3.4 Instrumentation and Control

STD DEP T1 3.4-1 (Figure 3.4b)

Figure 3.4a ~~Figure 3.4j~~ Safety System Logic and Control (SSLC) ~~Control~~ Interface Diagram

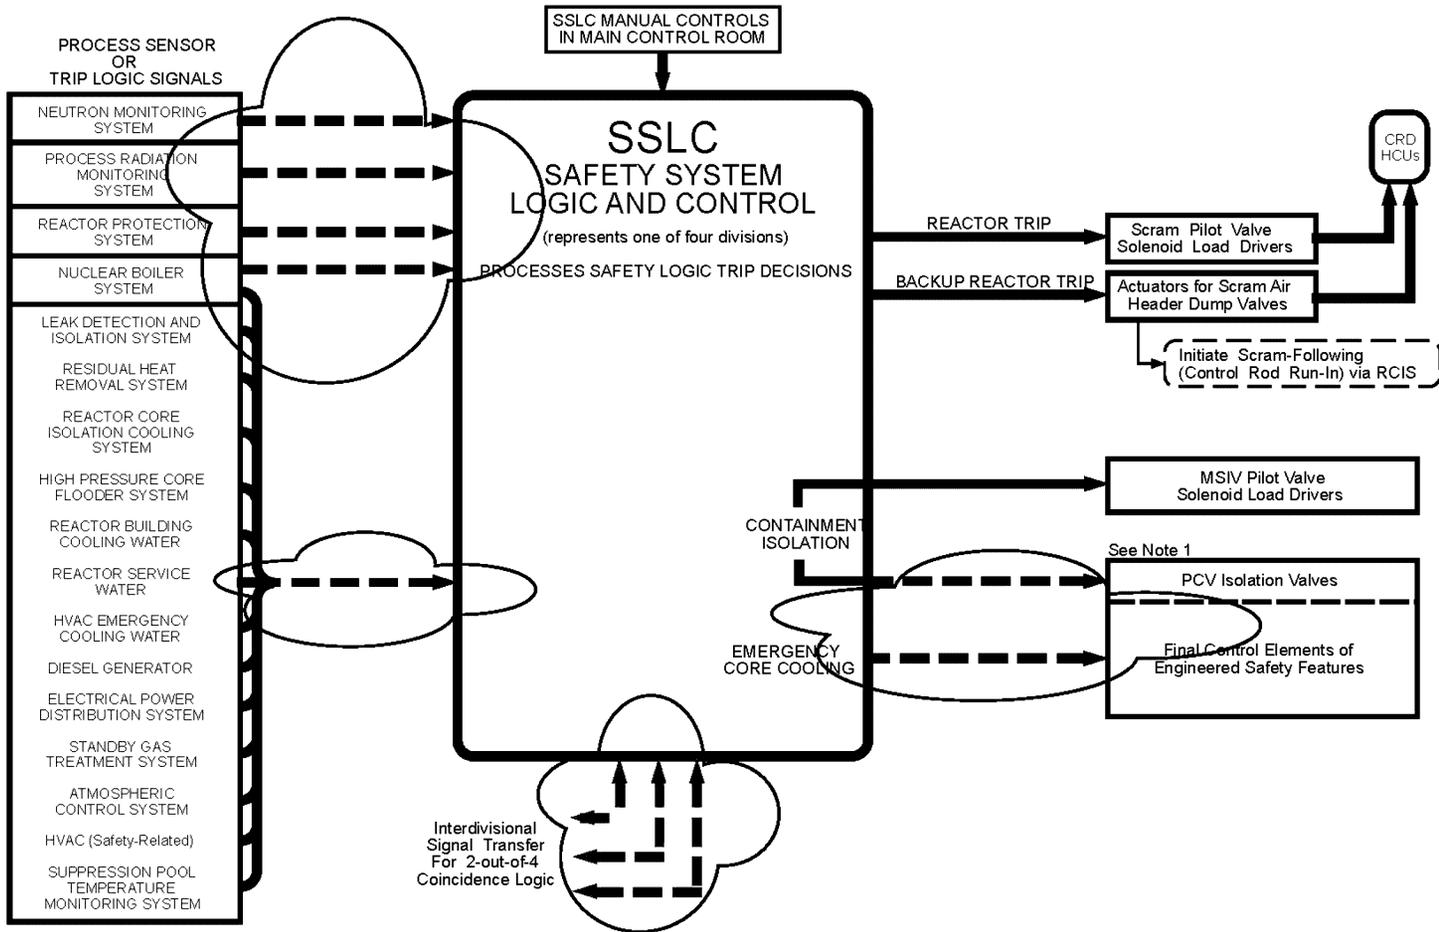
supports the accident mitigation functions. Also included in SSLC are the Neutron Monitoring System (NMS), the Containment Monitoring System (CMS) and the safety-related portions of the radiation monitoring systems. The relationship between SSLC and systems for plant protection is shown in Figure 3.4a.

Figure 3.4b Figure 3.4k Safety System Logic & Control Block Diagram

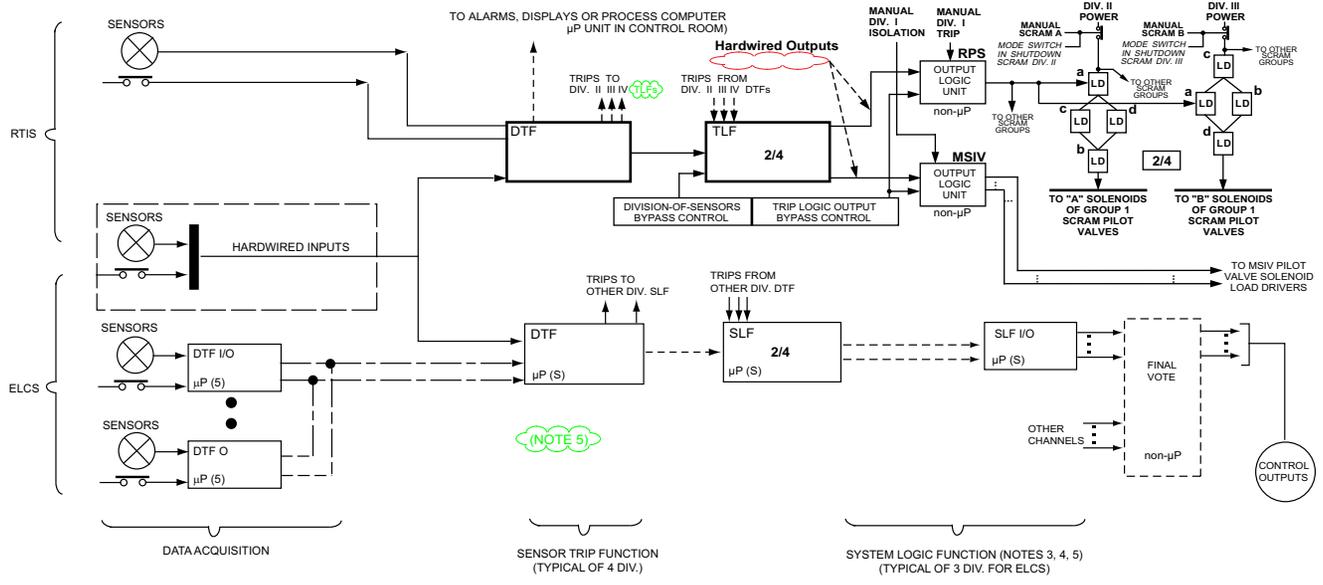
The basic hardware functional configuration for one division of SSLC is shown in Figure 3.4b. Each division runs independently (i.e., asynchronously) with respect to the other divisions. The following steps describe the processing sequence and associated function descriptions for incoming sensor signals and outgoing control signals. These steps are performed simultaneously and independently in each of the four divisions:

- (1) Remote sensor Sensor inputs are acquired, conditioned, and digitized.
- (2) *(1) The digitized sensor inputs from RMUs are received in the control room at control room multiplexing units (CMUs), which associate sensor signals with their logic processing channel. These sensor signals are decoded by a microprocessor based function, the Digital Trip Module (DTM). For sensor*

~~signals hardwired to the control room, the DTM also performs digitizing and signal conditioning tasks. For each system function, the DTM then compares these inputs to preprogrammed threshold levels (setpoints) for possible trip action. The DTM provides a discrete trip decision for each setpoint comparison.~~ This digitized sensor information is used as input to the Digital Trip Function (DTF). For each system function, the DTF is a comparison of sensor inputs to pre-programmed threshold levels (setpoints) for possible trip action. The result of the DTF is a discrete trip decision for each setpoint comparison. Each safety division performs the same DTF trip decision based on the independent sensor inputs associated with its own division.

- (3) ~~(2) Ford Reactor Protection System (RPS) trip and main steam isolation valve (MSIV) closure functions, trip outputs from the DTM are then compared, using a 2-out-of-4 coincidence logic format, with trip outputs from the DTMs of the other three divisions. The trip outputs are compared in by the trip logic unit (TLU), another microprocessor based device. The logic format for the DTM and TLU is fail safe (i.e., de-energize to operate). Thus, a reactor trip or MSIV closure signal occurs on loss of input signal or power to the DTM, but, because of the 2-out-of-4 logic format in the TLU, a tripped state does not appear at the output of the TLU (for a single division loss of power). Loss of signal or power to a division's TLU also causes a tripped output state, but the 2-out-of-4 configuration of actuator load drivers prevents de-energization of the pilot valve solenoids.~~ The trip decisions from the DTF in each division are used as input to the Trip Logic Function (TLF) performed by each of the four safety divisions. The DTF trip decision results are passed to other divisions through isolated communication links as described in Section 2.7.5. The TLF processes DTF trip decisions from all four safety divisions resulting in trip output decisions based on 2-out-of-4 coincidence logic format. The logic format is fail-safe (i.e. loss of signal causes trip conditions) for the TLF and associated DTF. Loss of signal or power to a single division's equipment performing the TLF causes a tripped output state from the TLF, but the 2-out-of-4 configuration of the actuator load drivers prevents simultaneous de-energization of both pilot valve solenoids.

~~As shown in Figure 3.4b, a pair of SLU are located in each of two engineered safety feature (ESF) processing channels, ESF1 and ESF2. ESF1 processes initiation logic for functions which service the reactor vessel at low pressure (e.g. RHR), while ESF2 provides the same support for the vessel at high pressure (e.g. Reactor Core Isolation Cooling (RCIC) System and High Pressure Core Flooder (HPCF) System). Associated LDS and ESF functions are also allocated to these logic channels.~~

1. ARRANGMENT SHOWN IS A SIMPLIFIED EXAMPLE FOR ONE DIVISION
2. A. NOT ALL CONTROL SWITCH INPUTS SHOWN.
B. INPUTS FROM NMS AND PRM NOT SHOWN.
C. INTERDIVISIONAL COMMUNICATIONS USE FIBER OPTIC DATA LINKS.

3. SAFETY SYSTEM LOGIC FUNCTION (SLF) FOR ECCS FUNCTIONS IS IMPLEMENTED WITH REDUNDANT CHANNELS WITH A MINIMUM 2/2 VOTE OF THE OUTPUT SIGNALS TO PREVENT INADVERTENT COOLANT INJECTION OR DEPRESSURIZATION DUE TO SINGLE SLF ELECTRONICS FAILURE. THE OUTPUT VOTE MAY BE ACCOMPLISHED EITHER BY DIRECT VOTE OF SLF OUTPUT SIGNALS OR BY A SYSTEM VOTE WHERE BOTH VALVE AND PUMP ACTUATION IS REQUIRED TO INITIATE SYSTEM ACTION. BYPASS OF A FAILED SLF CHANNEL MAY BE PROVIDED AS LONG AS THE REMAINING OPERATIONAL CHANNELS PROVIDE A MINIMUM OF TWO SLF CHANNELS FOR ECCS FUNCTIONS.

4. SAFETY SYSTEM LOGIC FUNCTION (SLF) FOR SOME ISOLATION AND SUPPORTING ESF FUNCTIONS MAY BE IMPLEMENTED WITH REDUNDANT CHANNELS WITH A NORMAL MINIMUM 2/2 VOTE OF THE OUTPUT SIGNALS WHERE INADVERTENT ACTUATION OF THE FUNCTION MIGHT REQUIRE UNREASONABLY SHORT REPAIR TIMES TO ELIMINATE OPERATIONAL IMPACT. FOR THESE FUNCTIONS, OPERATIONAL CONTROLLED BYPASS TO ALLOW OPERATION WITH A FINAL 1/1 VOTE IS PERMITTED.

5. EACH FUNCTION MAY BE ACCOMPLISHED BY MULTIPLE PROCESSORS TO MINIMIZE THE HARDWARE AND SOFTWARE COMPLEXITY OR OPERATIONAL IMPACT OF HARDWARE FAILURES, PROVIDED THE MINIMUM REDUNDANCY OF NOTES 3 AND 4 IS MAINTAINED.

Figure 3.4c ~~Figure 3.4~~ Anticipated Transient Without Scram (ATWS) Control Interface Diagram

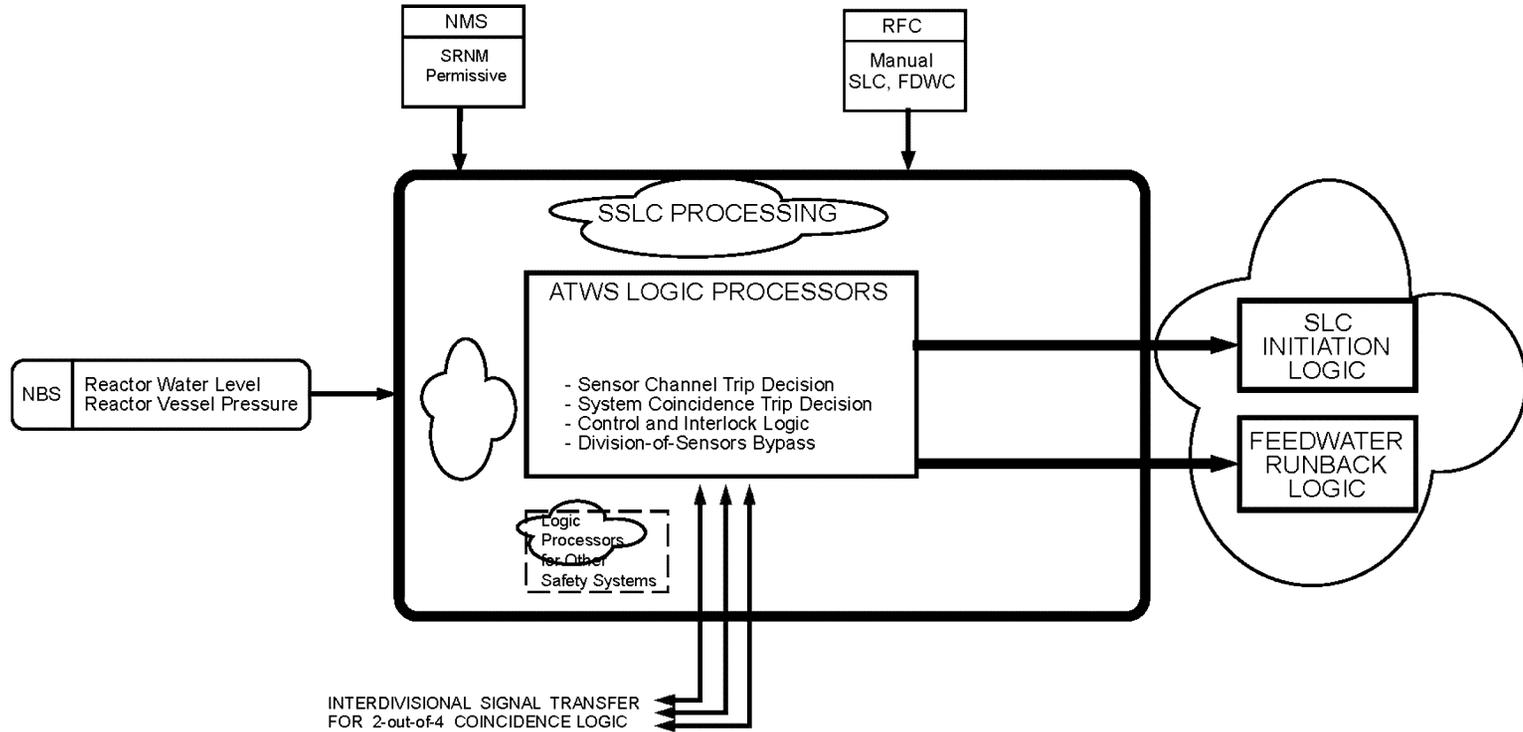
~~These ATWS features are implemented in four divisions of SSLC control circuitry that are functionally independent and diverse from the circuitry used for the Reactor Protection System (Figure 3.4c).~~
